THE HOTEL AT FOUNDRY PLACE, "LOT 3": 165 DEER STREET, ASSESSORS MAP 125 LOT 17, AND RELATED IMPROVEMENTS TO LOTS 2, 4 AND 5

SITE PLAN REVIEW

COVER SHEET

E1

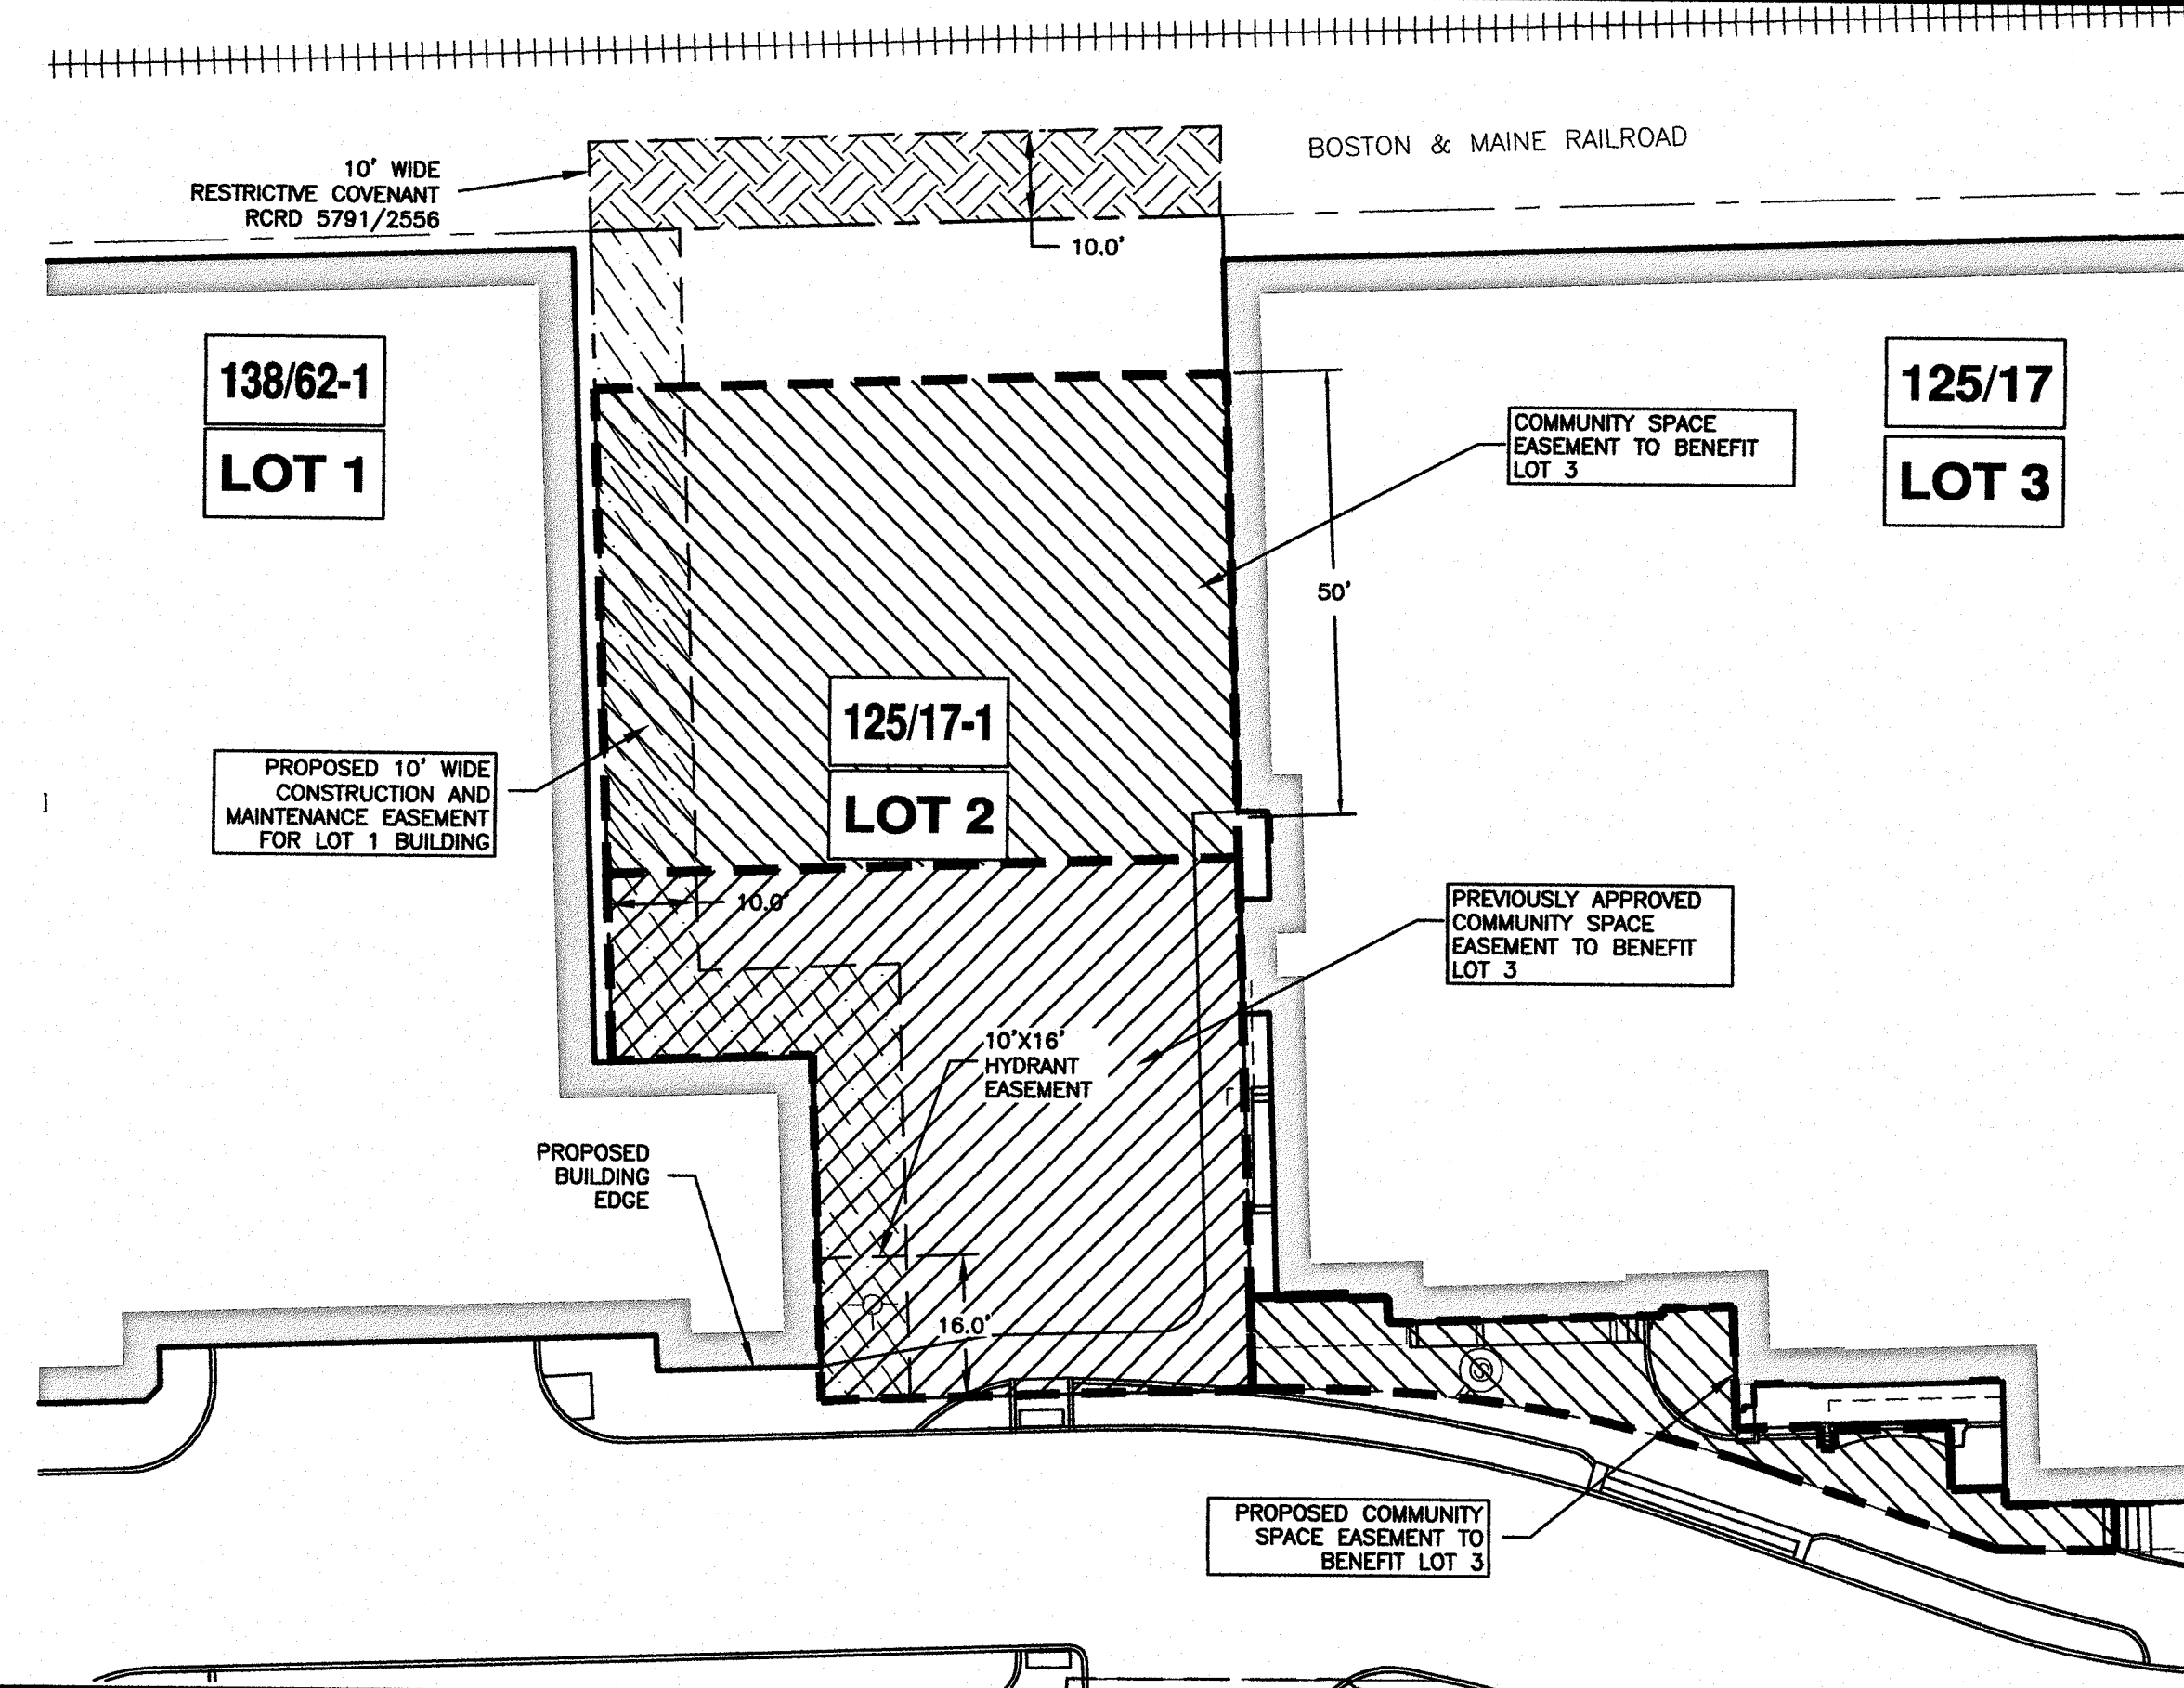
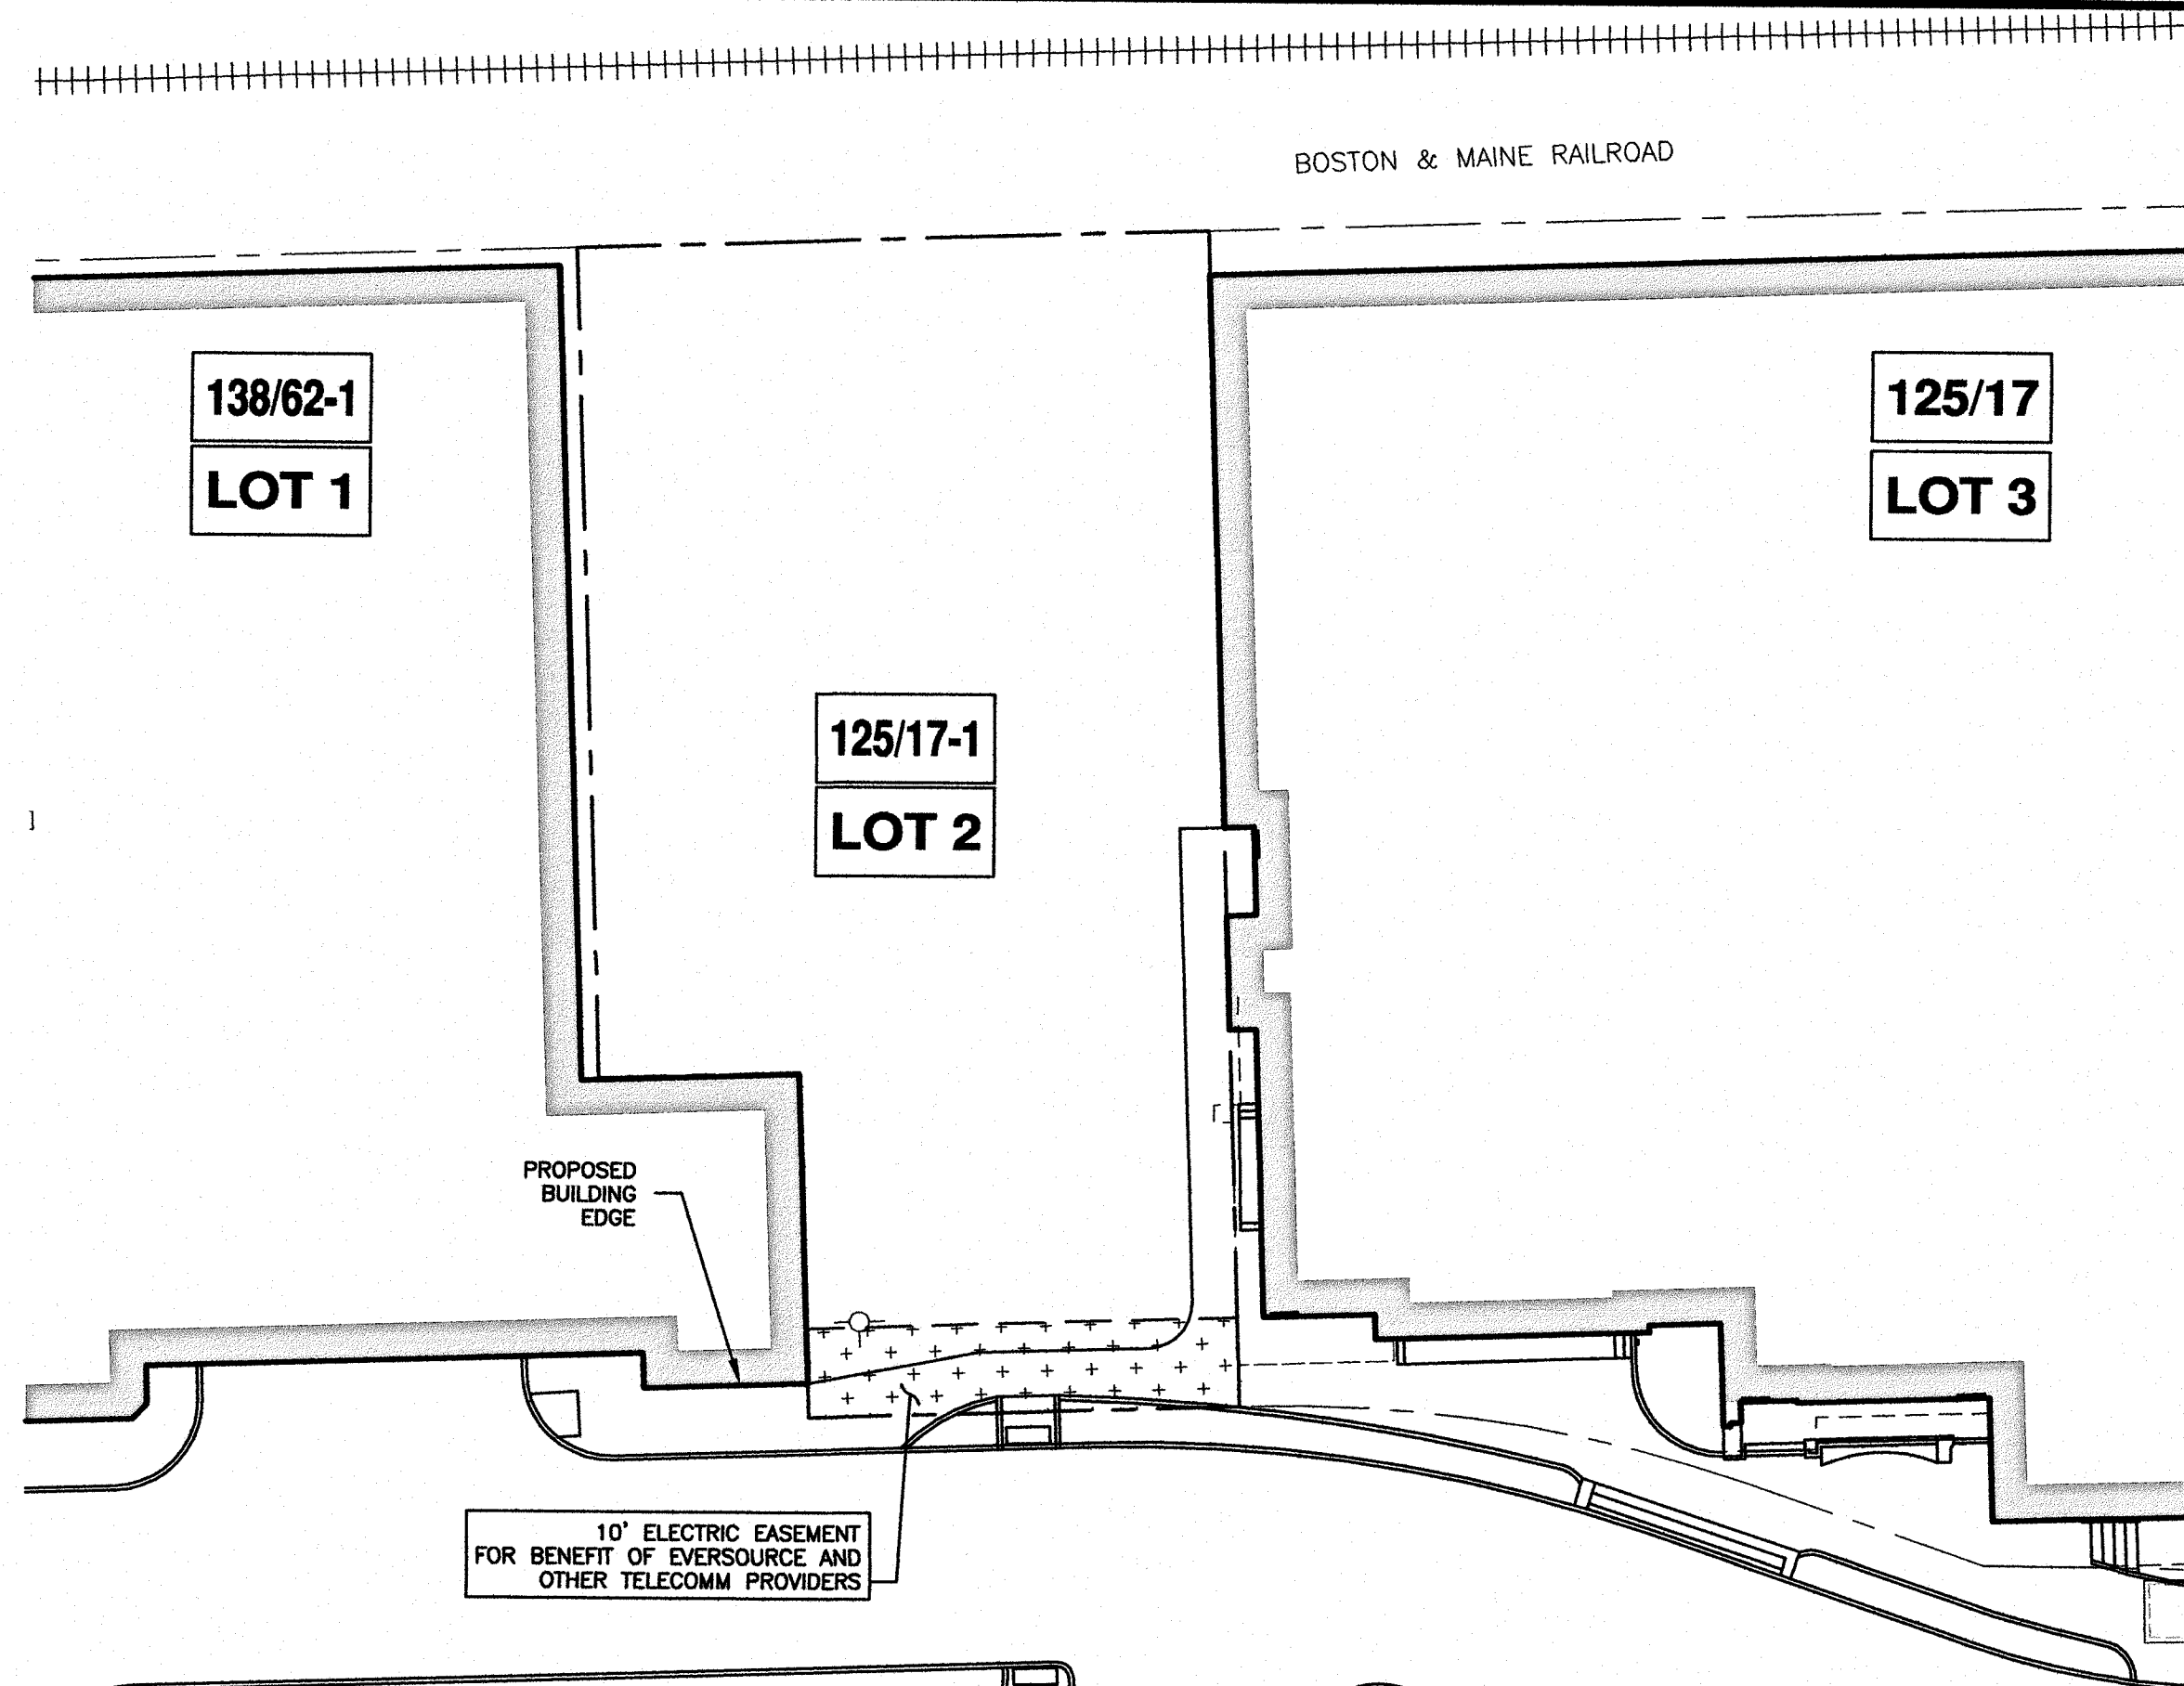
22	Update the Easement Table and Easement Figures to match; make sure it includes the electric easement on Lot 4 for Lot 3.	Resolved	Sheets E1, E2, and E3, and the Easement Summary Tables included in Attachment B were edited to be consistent and are included in the submittal.
23	City wants to control the ability to light the sidewalk, therefore they want decorative City street lights installed. Resolve light provided/guaranteed by building with City lights.	Addressed	Sidewalk lights are shown on Sheet L2. Updated building lighting information is included in Attachment G.
24	Update the zoning compliance table to include required dimensional information. Update square footage.	Addressed	Zoning compliance table updated. Dates of approvals for variances sought also included (Sheet T.02T).
25	Revisit Community Space calculation if outside tables are going to be used on sidewalks.	Addressed	Community Space calculations and illustrations (Sheet C3.3) was revised to exclude terrace area in front of hotel and is included.
